RENTECH, INC.

October 12, 2001

PETITION REVIEWER'S QUESTIONS

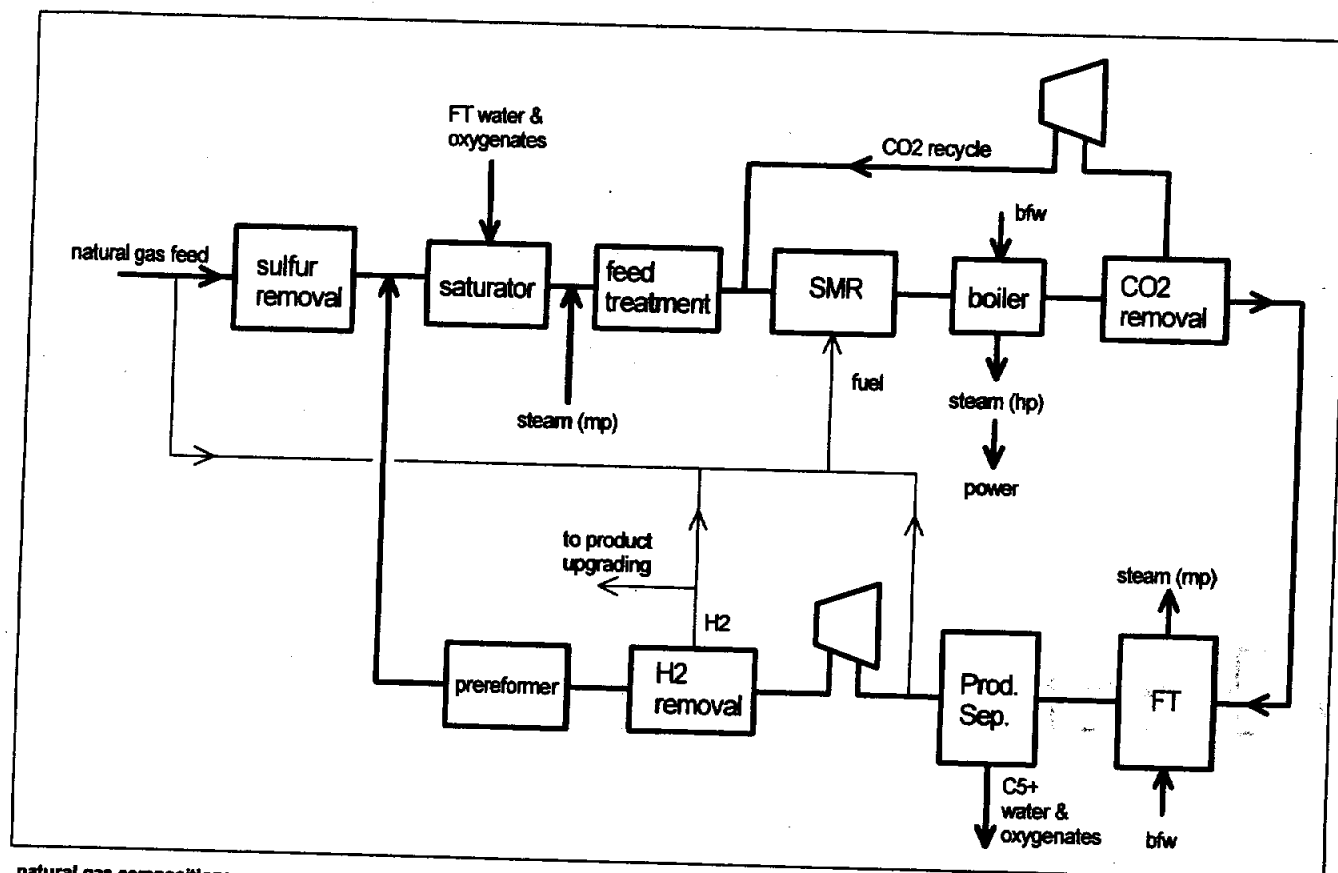
16. *The petition gives a batch analysis of the Rentech diesel with the emissions test results. Is the analysis typical of the Rentech diesel covered in the petition? If not, which fuel properties may vary? How much can the fuel properties vary from the results given in the batch analysis in the petition?*

All diesel analysis is batch analysis, and yes all fuels, including commercial diesel, will vary in analysis. We suggest that the DOE consider defining FTD with a range of specifications and our fuels will fall into those ranges.

See our Fuel Specifications and Recommended FTD Specifications attached.
